City of Fremont
Newaygo County, Michigan
Wastewater Lagoon Improvements

PROJ #2023755002.00

ADDENDUM #1

DATE:07/31/23

Sheet:
G5

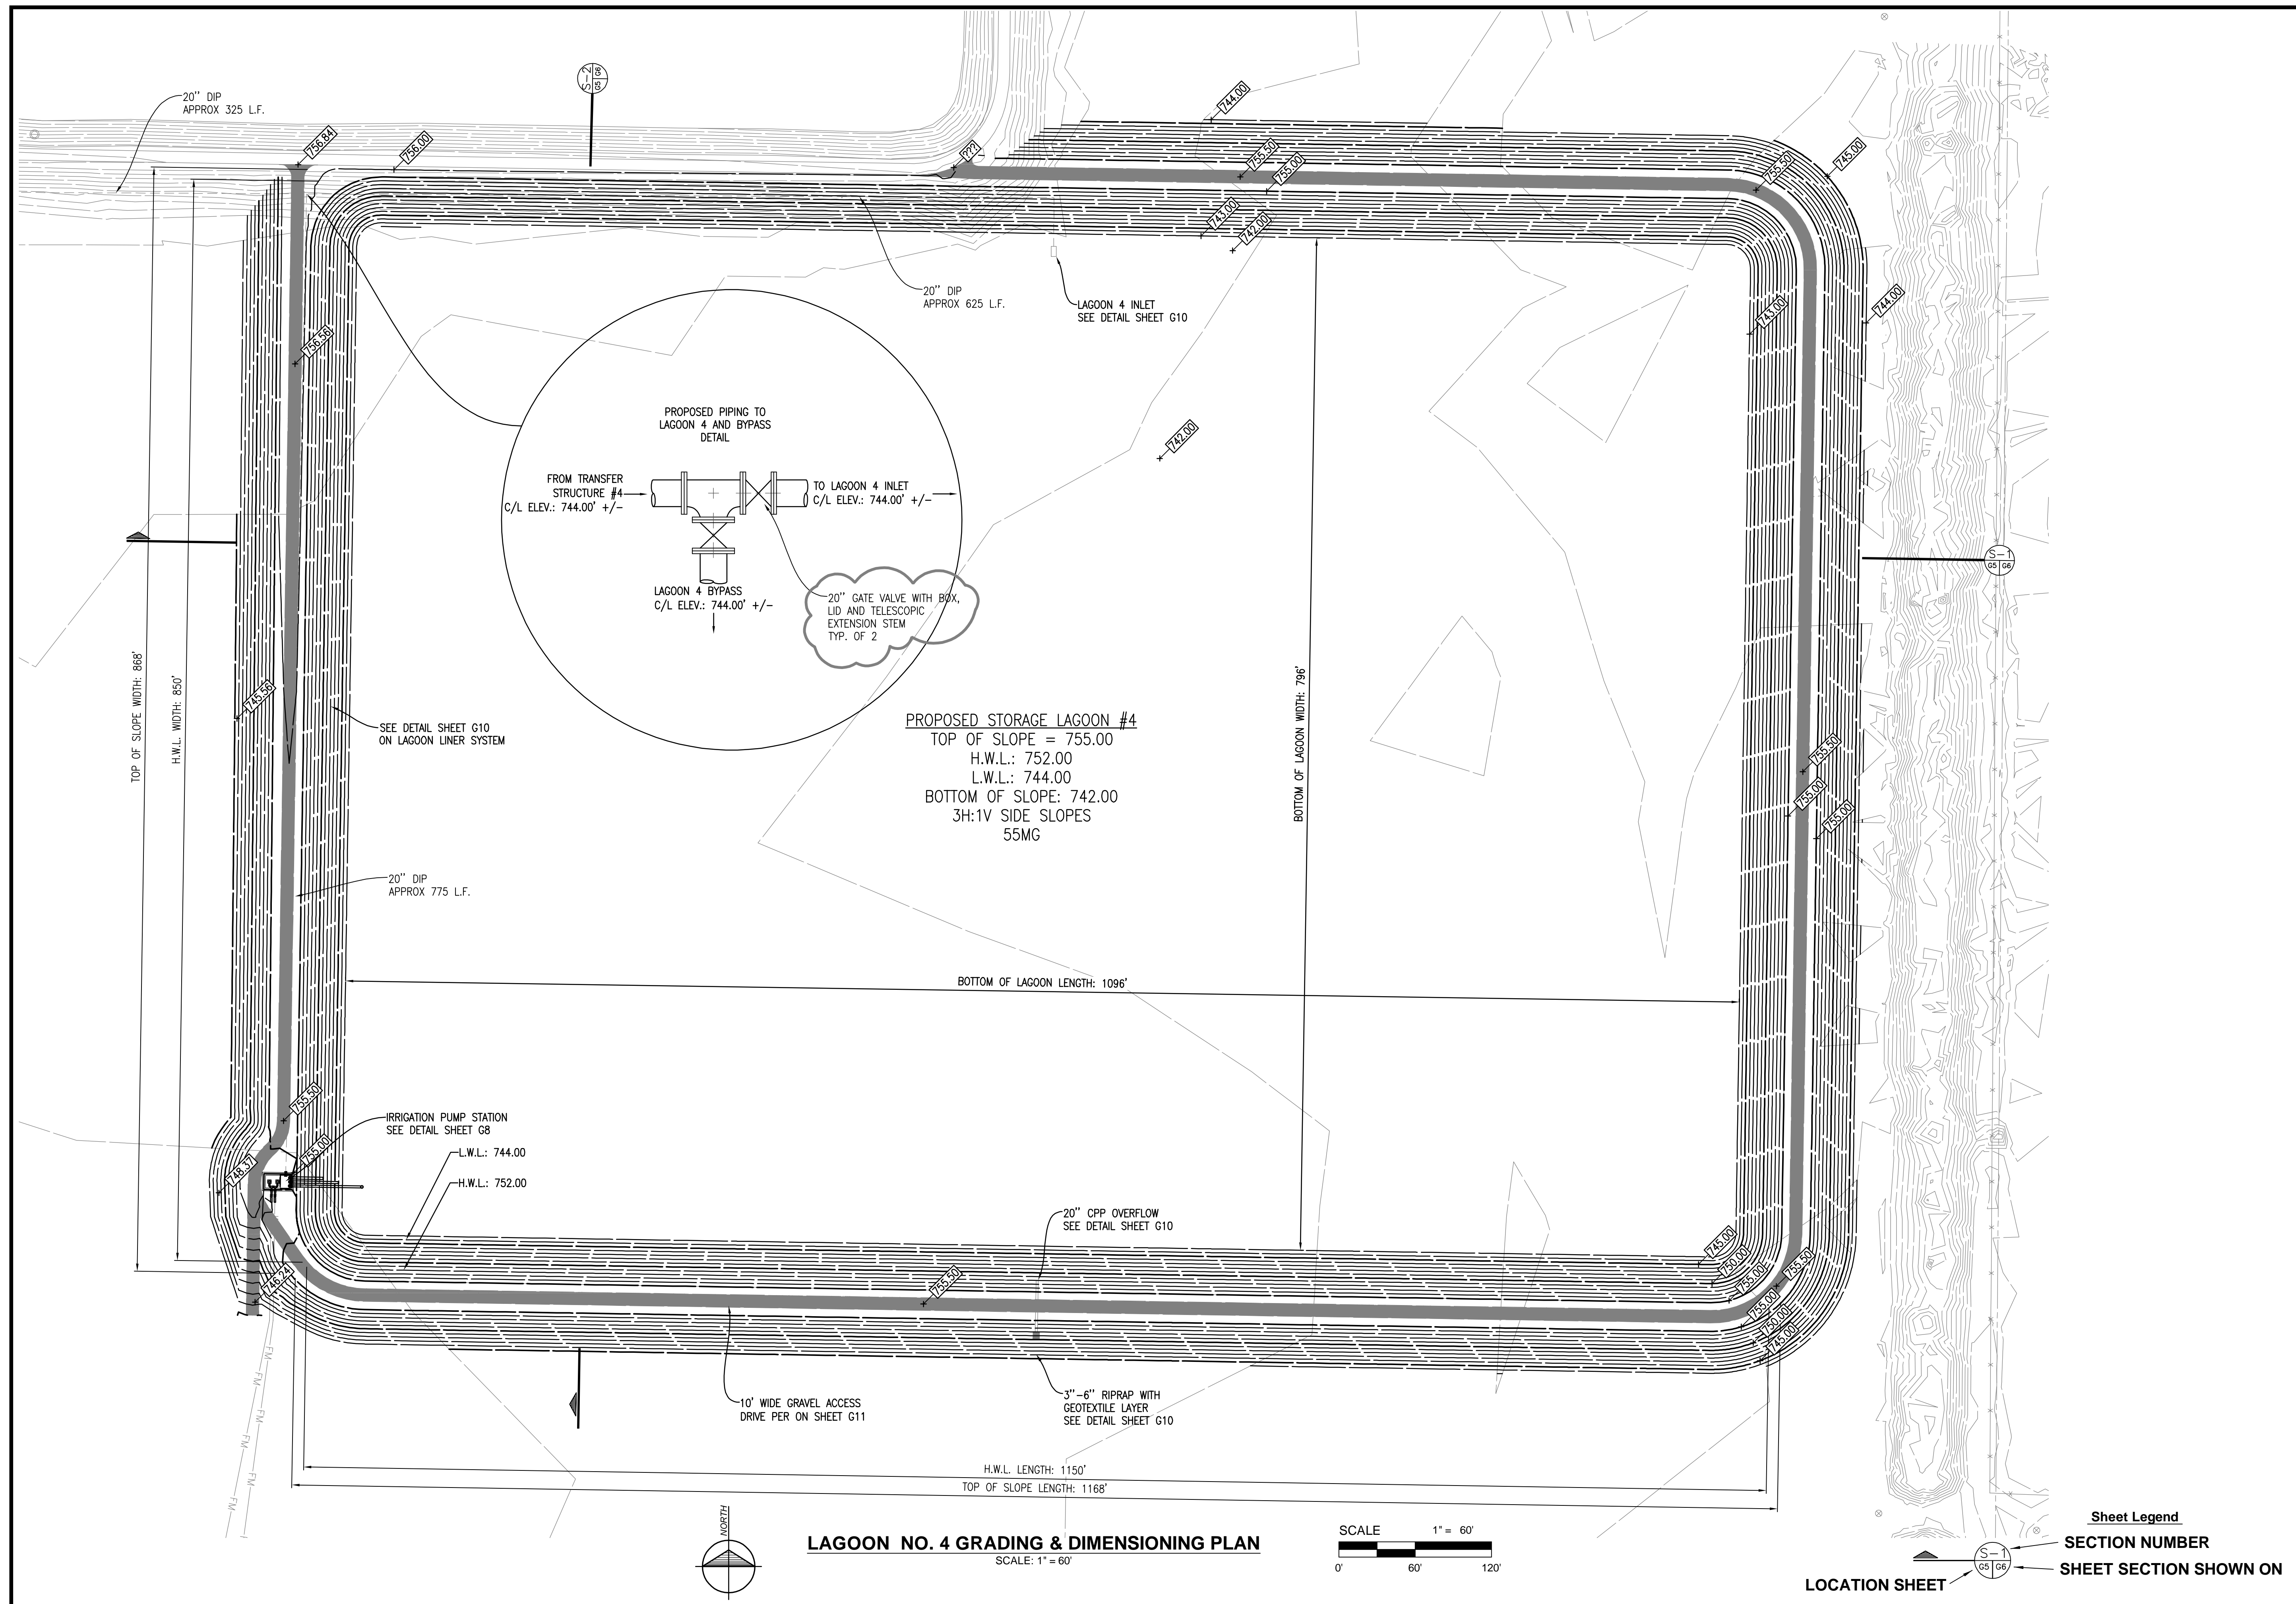
3. Is there a specific MJ bolt & nut material requirement for buried hardware?
Buried MJ hardware shall be coated steel or stainless steel.
4. Sheet G5: please confirm the type of valves for the Lagoon 4 inlet and bypass lines are to be RW Gate Valves. They are drawn as such, but no specific call-out is shown.
Slide gate replacement at existing transfer structure is no longer part of this project.

7. Sheet G5 – is the Lagoon #4 overflow to be concrete pipe?
Overflow Pipe shall be 20” CPP (such as N12) as noted on G5.
8. “3.03 SAND AND GRAVEL PLACEMENT

1. **G5: REPLACE** with attached: Lagoon 4 By-passing piping valves to be gate valves with box, lid and telescopic extension stem.
2. **G7: REPLACE** with attached: Replacement of existing sluice gates has been eliminated from the project.
3. **G8: REPLACE** with attached: Irrigation Pump Station Plan: 10” **Ball Plug** Valves
4. **G10: REPLACE** with attached: Overflow pipe to be 20” CPP, Road Gravel to extend over anchor trench to top of basin stone anchor system, in addition to access road as shown on plans. Sand cover to be 12” with 6” stone.
